Attn: Dan Reisman, Planning Board Chair
Re: **129 W. Genesee Street Splash Car Wash – Site Plan Review**

The following letter has been written in response to the review comments from Napierala Consulting dated September 7, 2022, received from the Village of Fayetteville on August 24, 2022. The following comments have been addressed below.

DRAWING TITLE: **UTILITY PLAN**

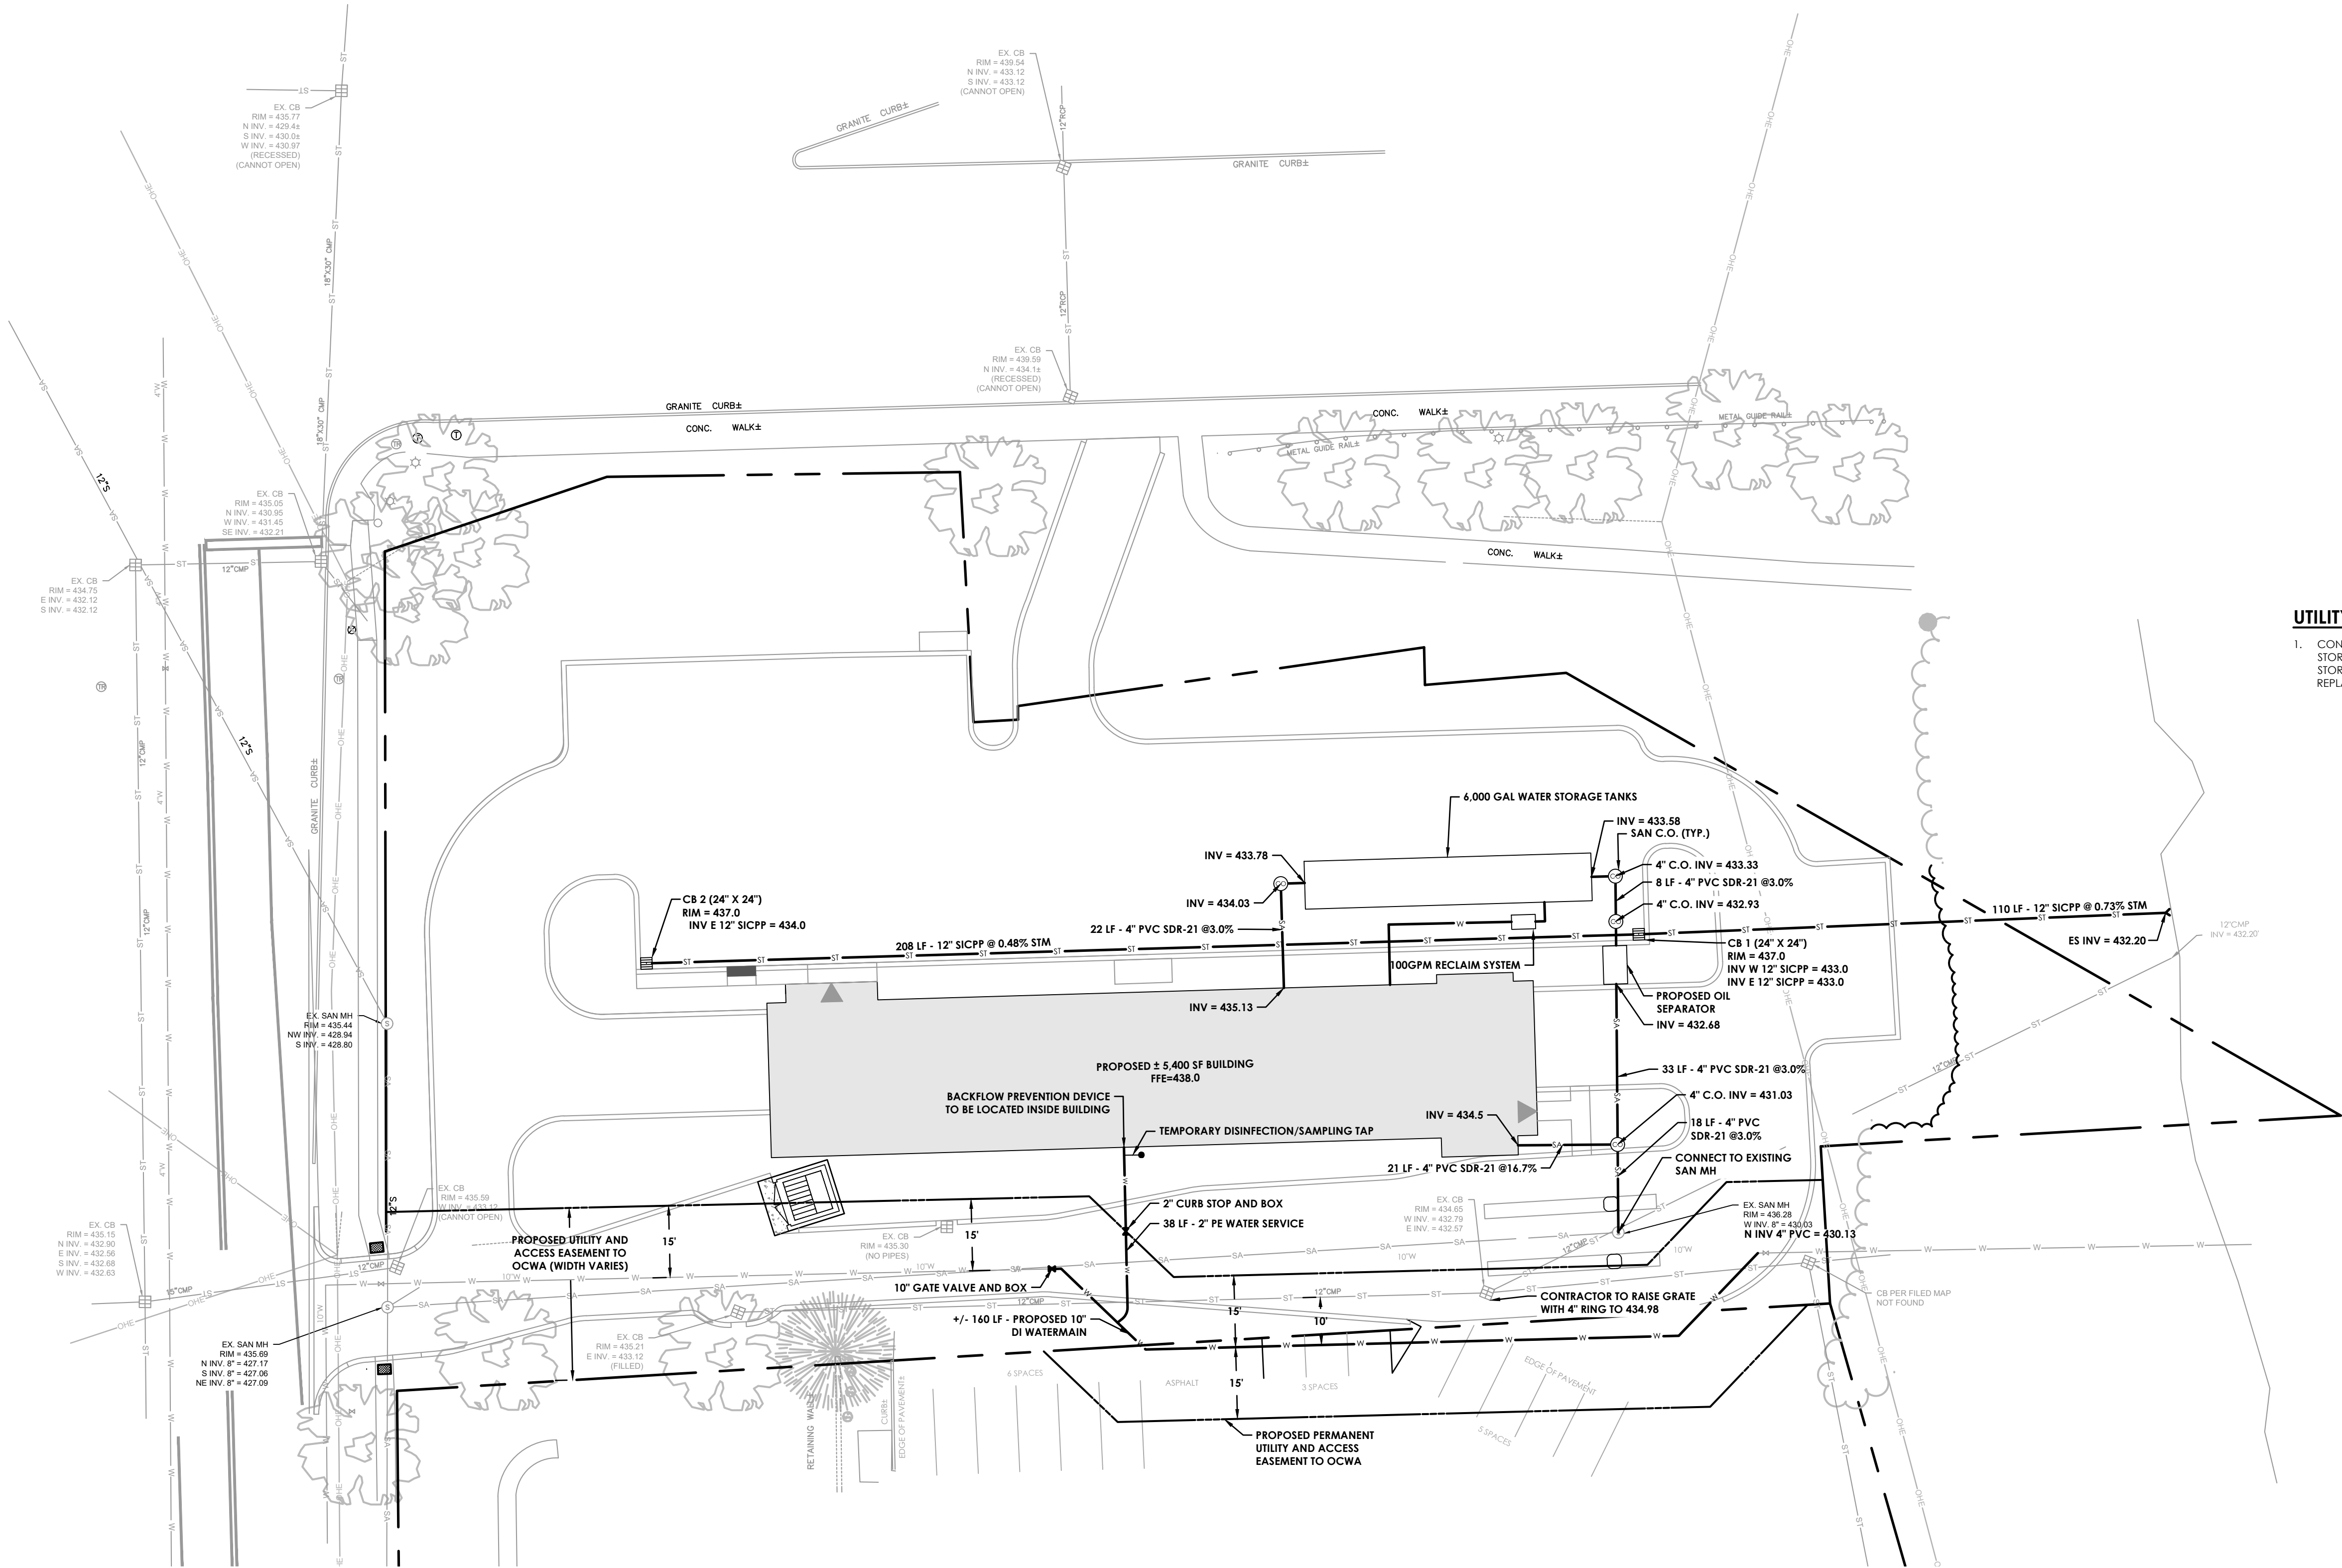
- a. Coordinate any new/required utility easements for water and sewer within the former Fitch Street right of way with the respective county agencies. This comment still stands and should be coordinated prior to site plan approval. If the waterline requires an easement with OCWA, it is likely to be of significant width and OCWA may limit (restrict) permanent structures in their easements (light poles, the pay stations, etc...). We encourage you to reach out to Steve Drake at OCWA (sjdrake@OCWA.org, (315) 455-7061 x 3154) for further discussion on the water easement.
The proposed plan has been submitted to Steve Drake at the OCWA. A watermain realignment and new easement will be required as part of the development now that semi-permanent improvements are proposed over the existing watermain location. The developer and OCWA have agreed upon the proposed watermain realignment show on the revised plans, see sheet C4.

- d. The planning should be made aware of the water connection from OCWA. Is an exterior RPZ with meter required in a hot box and if so how is this accomplished on the site and how is it screened. Merely stating that the applicant is aware of the need of OCWA does solve the potential issues.
A new backflow prevention device (RPZ) will be located inside building, see revised utility plan, sheet C4.

- f. The applicant is obligated to have knowledge of the working storm sewer system. If it is not properly functioning as shown on the site plan the planning board should be made aware of the engineered design solution. This should not be left for a field call during construction with no oversight.
We are not aware of any existing drainage issues onsite. If any existing storm infrastructure is found to be substandard during construction, it will be replaced in-kind. A note to this affect has been added to the revised utility plan, see sheet C4.

1. CONTRACTOR TO ACCESS/ASSESS THE CONDITION OF THE EXISTING STORM SEWER SYSTEM PRIOR TO CONSTRUCTION. ANY EXISTING STORM INFRASTRUCTURE FOUND TO BE SUB-STANDARD SHALL BE REPLACED IN KIND.

GRADING PLAN

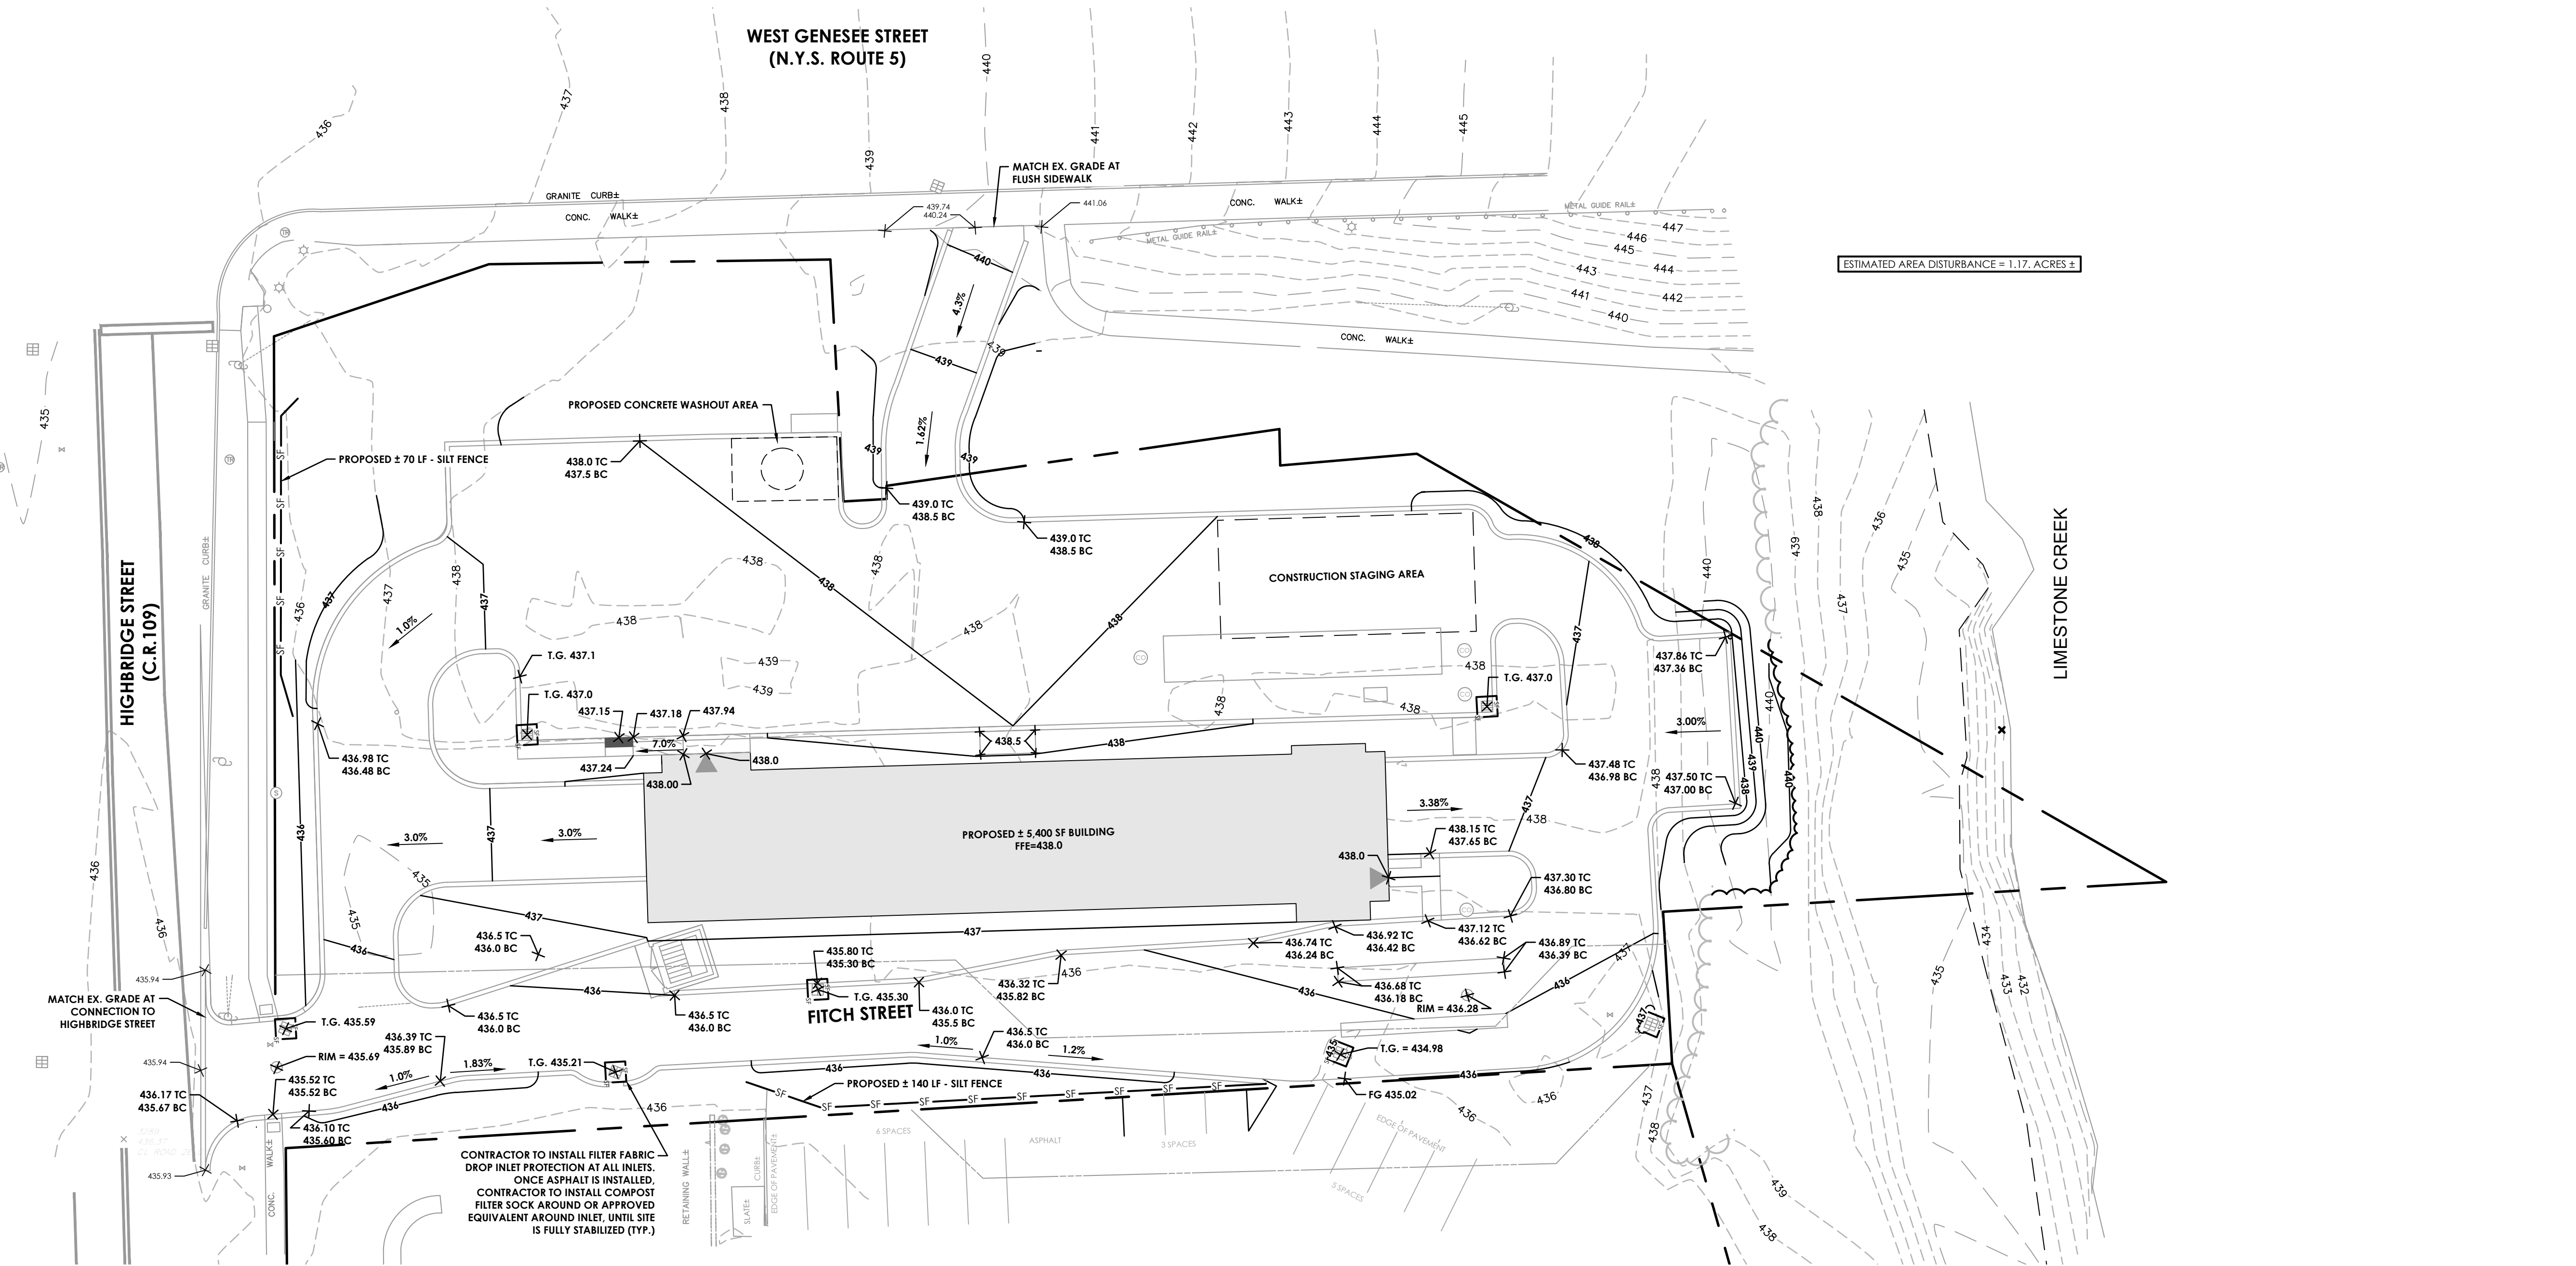
- f. Work in a FEMA designated Floodway is a critical element. Demonstrating a net export across the site does not necessarily meet the performance standard of “No Rise” and “No adverse Effect” for work within a Floodway. See the attached link / guidance document from NYSDEC <https://www.dec.ny.gov/lands/24281.html> .
DDSE will continue to work with the architect, Village staff, and Village Engineer to provide documentation and calculations required to be compliant with state and local guidelines for development within the floodway.
- c. The route 5 driveway grading still needs attention. A highpoint is noted at 439.5 however flows north to a proposed 439 contour that is tied into an existing 440 contour. This would create an errant low spot.
The grading plan has been revised to correctly show the existing tie-in point. See revised grading plan on sheet C5.
